UNITED STATES PATENT AND TRADEMARK OFFICE

| APPLICATION NO. | FILING DATE | FIRST NAMED INVENTOR | ATTORNEY DOCKET NO. | CONFIRMATION NO. |
|-----------------|-------------|----------------------|---------------------|------------------|
| 10/604,900 | 08/26/2003 | Susan P. BEACHAM | MSG4 | 1899 |

Office Action Summary

Corrected Drawing/Patent App.
s. and M. Beacham/10/604,900
/Compartmented Piggy Bank

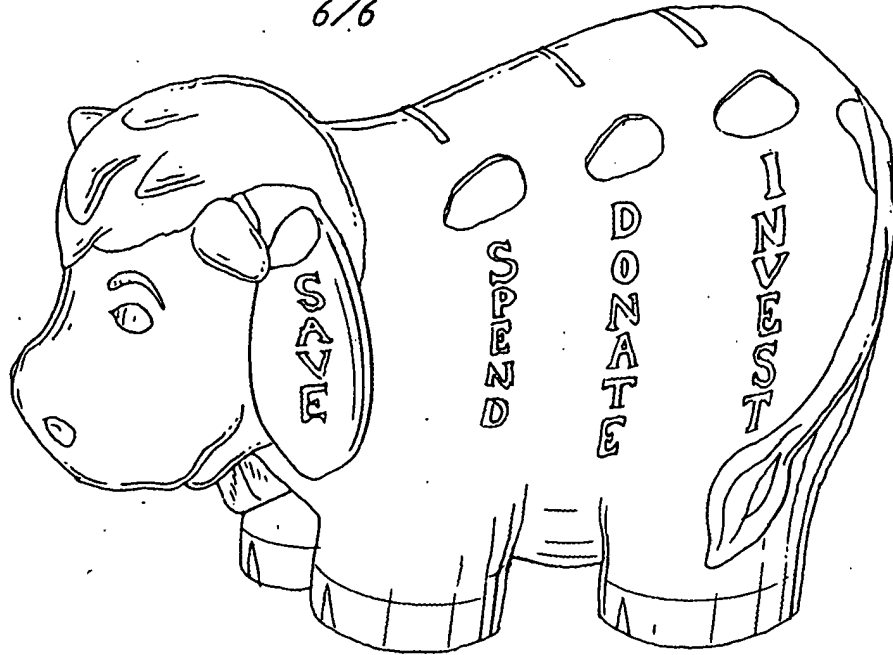
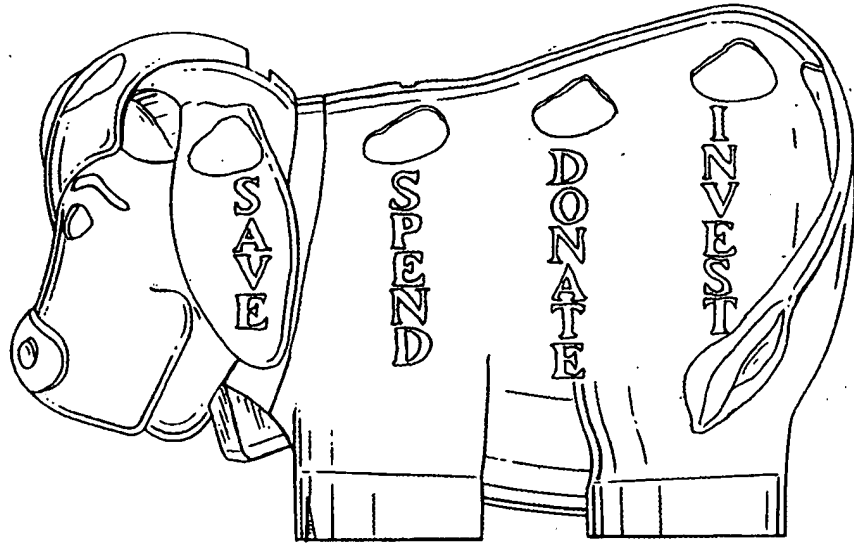
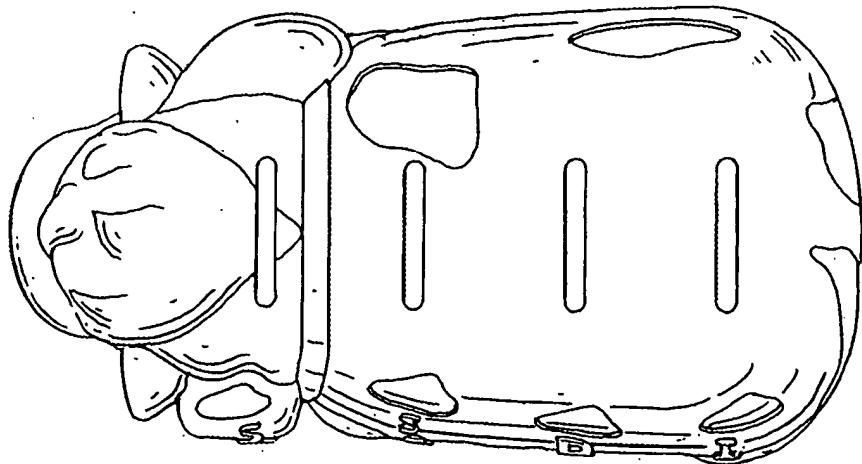
2. The drawings received on 03-16-2005, namely sheet 6/6 and Figs. 6-8, are objected to as introducing new matter, specifically a compartment located in the ear of the cow. Consequently, these drawings have not been entered, and the originally filed drawings remain objected to under 37 CFR 1.83(a). The drawings must show every feature of the invention specified in the claims. Therefore, the cow (claim 9) must be shown or the feature(s) canceled from the claim(s). No new matter should be entered.

NOT APPROVED W.M. 7/6/05

3. Corrected drawing sheets in compliance with 37 CFR 1.121(d) are required in reply to the Office action to avoid abandonment of the application. Any amended replacement drawing sheet should include all of the figures appearing on the immediate prior version of the sheet, even if only one figure is being amended. The figure or figure number of an amended drawing should not be labeled as "amended." If a drawing figure is to be canceled, the appropriate figure must be removed from the replacement sheet, and where necessary, the remaining figures must be renumbered and appropriate changes made to the brief description of the several views of the drawings for consistency. Additional replacement sheets may be necessary to show the renumbering of the remaining figures. The replacement sheet(s) should be labeled "Replacement Sheet" in the page header (as per 37 CFR 1.84(c)) so as not to obstruct any portion of the drawing figures. If the changes are not accepted by the examiner, the applicant will be notified
